Access Compliance Report

Public Rights-of-Way

Intersection ID: 46754	Main Street: SUPERIOR_ST	Cross Street: TAHOE_DR	Location: S
ADA ID: AC1CB8D8A6C8	Ramp Type: BlendTrans1	Initial Pass/Fail: Fail	Overall Compliance: No
		Severity Score: 10

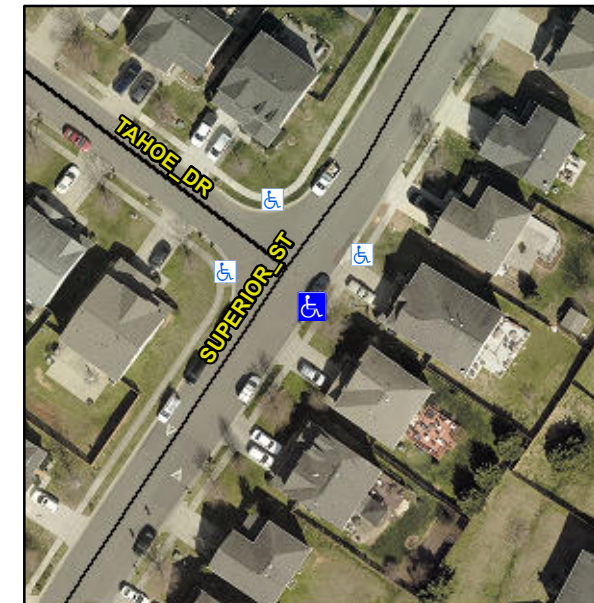
R304.5.1

Compliance	Description	Data	Compliance	Description	Data
N/A	Ramp Length (in)	47.0	Yes	BlendTrans Slope (%)	4.0
No	Ramp Width (in)	47.0	Yes	BlendTrans XSlope (%)	4.7
N/A	Flare Type LT	N/A	N/A	Flare Type RT	N/A
N/A	Flare Slope LT (%)	N/A	N/A	Flare Slope RT (%)	N/A
N/A	Flare Traversable LT?	N/A	N/A	Flare Traversable RT?	N/A
N/A	Landing Length (in)	N/A	N/A	DWS Provided?	N/A
N/A	Landing Width (in)	N/A	N/A	DWS Contrast?	N/A
N/A	Landing Slope (%)	N/A	N/A	DWS Length (in)	N/A
N/A	Landing X Slope (%)	N/A	N/A	DWS Full Width?	N/A
N/A	Landing Curb? (Y/N)	N/A	N/A	DWS Offset (in)	N/A
N/A	Shared Landing?	N/A			
N/A	Gutter Ponding?	N/A	N/A	Gutter Slope (%)	N/A
N/A	Gutter Lip Ht (in)	N/A	N/A	Gutter X Slope (%)	N/A
N/A	Painted X Walk1?	No	N/A	Painted X Walk2?	N/A
	X Walk 1 Direction	To NW		X Walk 2 Direction	N/A
	X Walk 1 Width (in)	N/A		X Walk 2 Width (in)	N/A
	X Walk 1 Slope (%)	2.1		X Walk 2 Slope (%)	N/A
	X Walk 1 X Slope (%)	5.4		X Walk 2 X Slope (%)	N/A

Remove & Replace Curb Ramp With Two New Directional Ramps or Equivalent.
